SANITARY SEWER LAY OUT
LANKIN ADDITION
Wichita, Kansas
R.S. DELAMATER
CONSULTING ENGINEER
WICHITA, KANSAS

We are handing you herewith the tracings for the 48" storm sewer and the sanitary sewer which have been constructed to serve the Lankin Addition.

48" Storm Sewer Layout
Lankin Addition
May, 1969
R.S. Delamater
Consulting Engineer
Wichita, Kansas

231-A-100

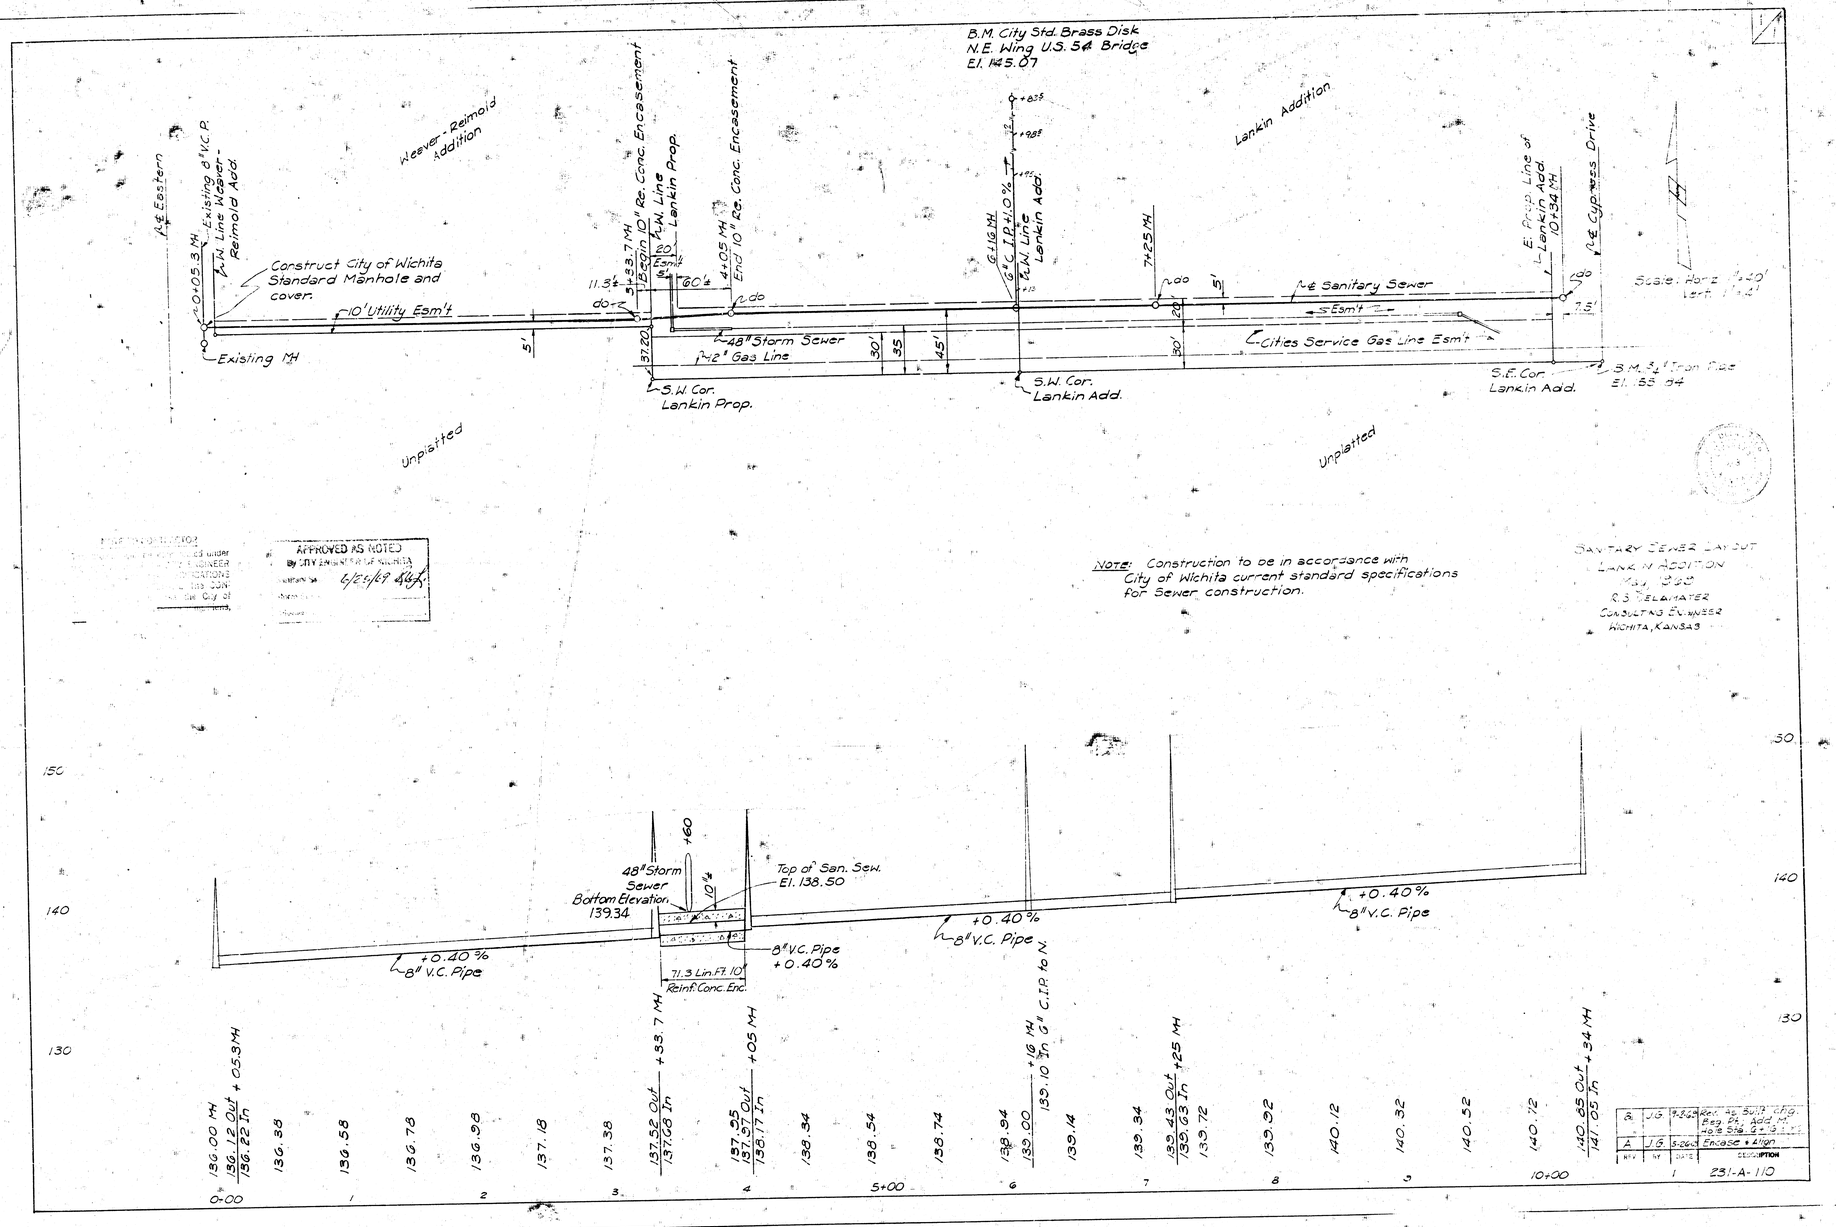
These tracings have been corrected to indicate the grades and dimensions as built and also to include the connecting lines into the sewers; in the case of the storm sewer we have indicated the location, flowline and grate elevation of the inlets which discharge into the manhole at the eastern end of the line.

NOTE, As built: All concrete manholes are built with standard concrete bottom sections, and brick extensions, with 2' square grate tops.

~~Bott. 12" Gas Line El. 149.77~~ 149.36 In (Lowered to below 48" Storm Sewer)

Note: As built revisions 12.5-69 are to show changes in the fields by others, and do not reflect changes in the plans by the consultant.
